# SERVICETEKNOTES

## TABLE OF CONTENTS

## S-3200 2943/2944 CORRECTION FOR SIGNAL EDGE JITTER

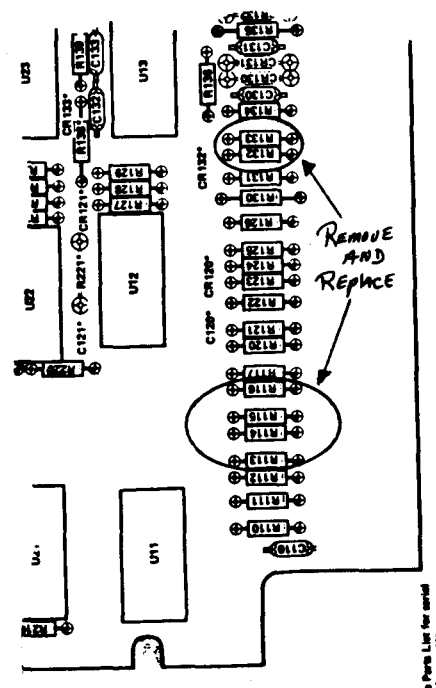
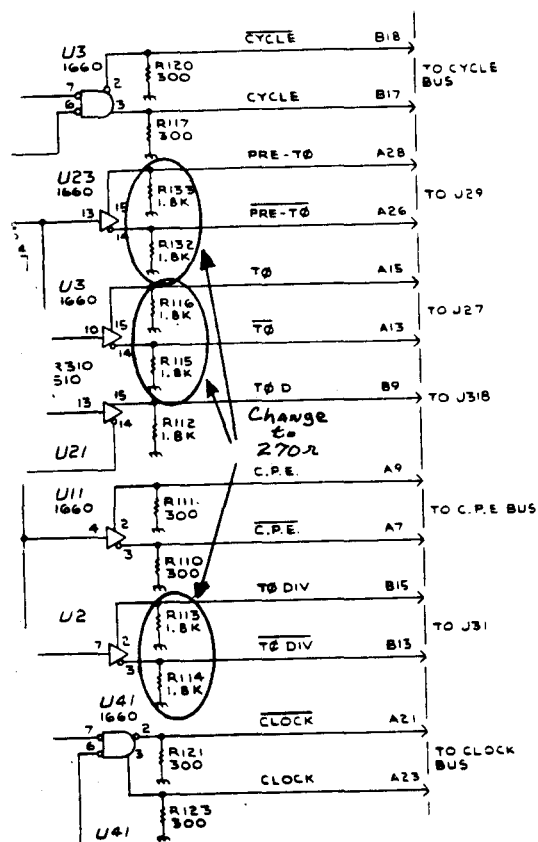
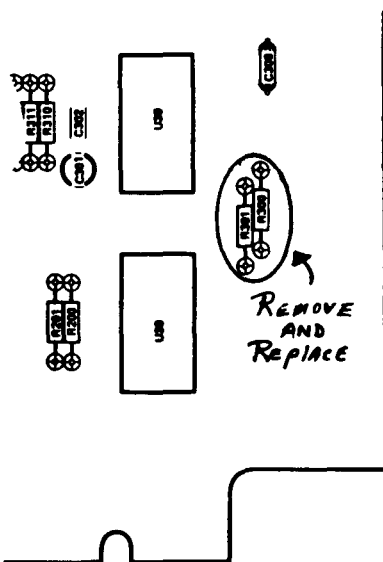
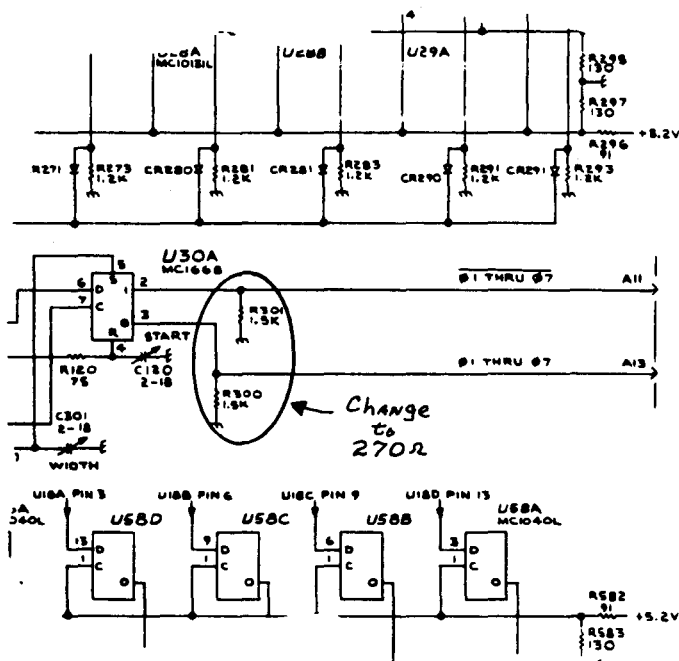
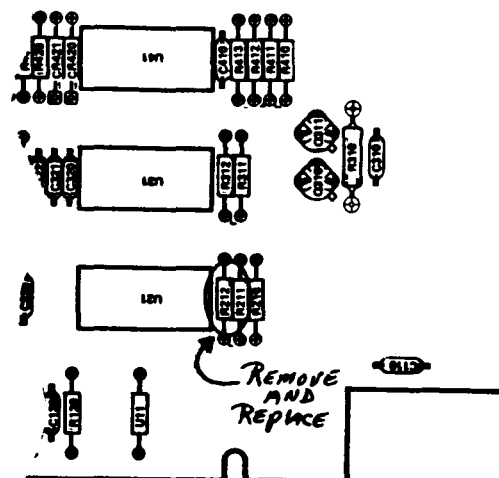
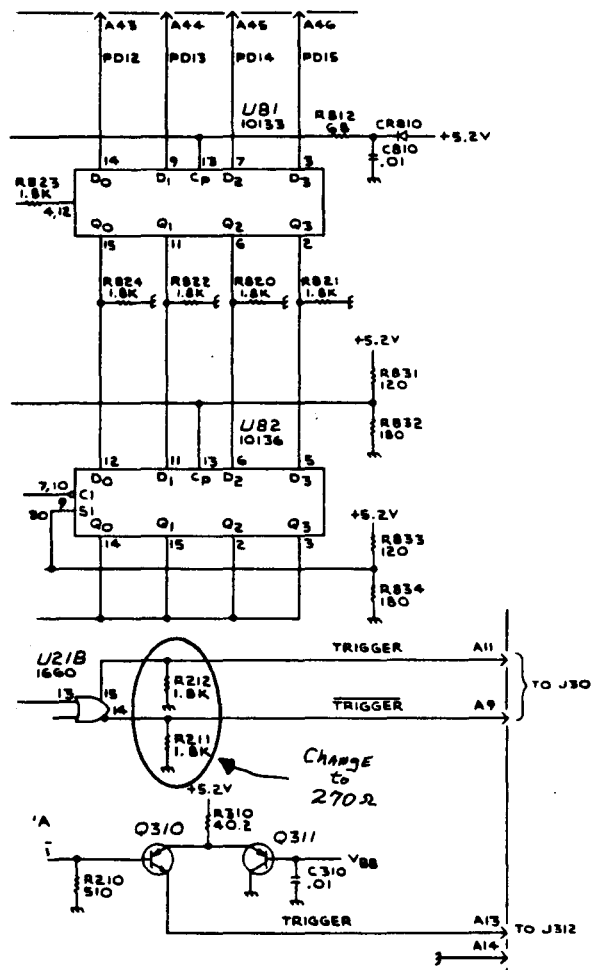
In some 2943/2944 clock generators the clock signal edges may vary (jitter) between 400 ps to 1 ns. The jitter is caused by high signal impedance, signal sources and cross talk to adjacent signals.

The solution is to decrease source impedance to increase the drive current. This will stabilize the signal and reduce cross talk effects.

On the Cycle Length Board 670-5383-05 change R113, R114, R115, R116, R132, R133 from 1.8K P/N 315-0182-00 to a 270 ohm P/N 315-0271-00. Change board P/N to 670-5383-06. On the Clock Phase Board 670-5425-01 change R300 and R301 from a 1.5K ohm P/N 315-0152-00 to a 270 ohm P/N 315-0271-00, change board P/N to 670-5425-02. On the Programmed Cycle Board 670-5417-01 change R211 and R212 from 1.8K ohm P/N 315-0182-00 to 270 ohm P/N 315-0271-00, change board P/N to 670-5417-02.

The following are locations of the changes on partial drawing of schematic and parts layout:

Figure 1. Drive 0

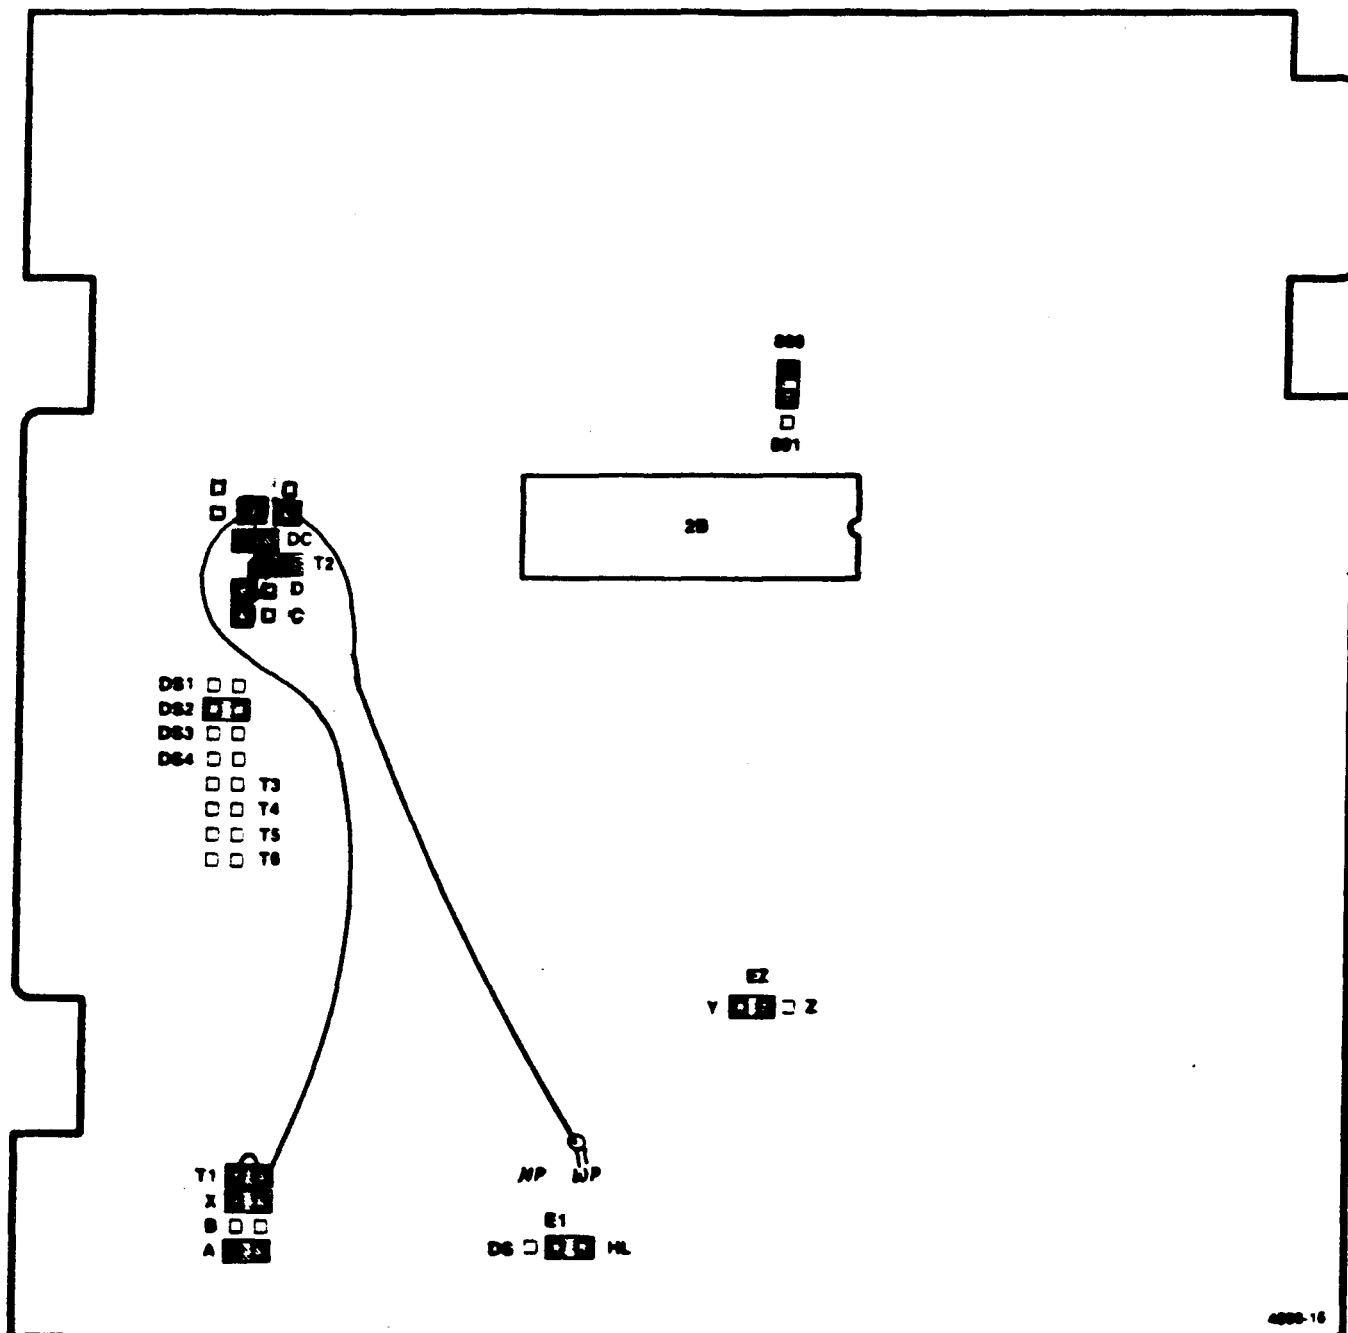
The wire jumpers that we install are different. The wires are installed as shown in fig. 1 and fig. 2. The cables and straps will be covered in the F45 Disk Option Service Manual (available Week 36) and a correction is being done to the F42/43 Disk Option Service Manual.

Fig 1. Schematic Diagram

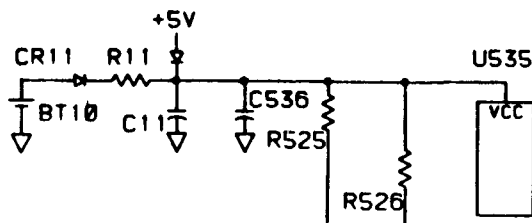
The NiCad battery on the Processor board has had a high rate of failures. This battery, p.n. 146-0040-00, is used to power the CMOS RAM which stores the user selectable operating parameters. If the battery fails, the set up parameter stored will be returned to their default conditions. This is indicated by a message, "Setup Default Reset", displayed on the screen at power-up. The replacement battery is a lithium battery, p.n. 146-0045-00, with a life rating of ten years, and requires no charging circuit. The charging circuit components will be removed with the old NiCad battery.

To implement Mod 51340, refer to Fig. 1 and 2 while doing the following steps:

1. Remove CR9, CR10, CR11, BT10, R11.
2. Add new CR10 (152-0322-00) to replace old CR10.
3. Cut run on surface of board between R11 and CR11.
4. Insert CR11 (152-0322-00) where R11 was removed. Place CR11 in the circuit so the anode is to the battery and the cathode is connected to the run just cut.
5. Move R9 (270 ohms) to bridge the cut run. Attaching one leg to the cathode of CR11 and the second leg to the pad at the other end of the cut run. This 270 ohm resistor will now be referred to as R11.
6. Install the new battery to replace the old battery which was removed. Keep the negative lead short. This battery is slightly longer than the one removed. It will need to be installed at a slight angle for clearance. Use the insulation to cover the positive lead which will need to loop back to the pad labeled with a plus.
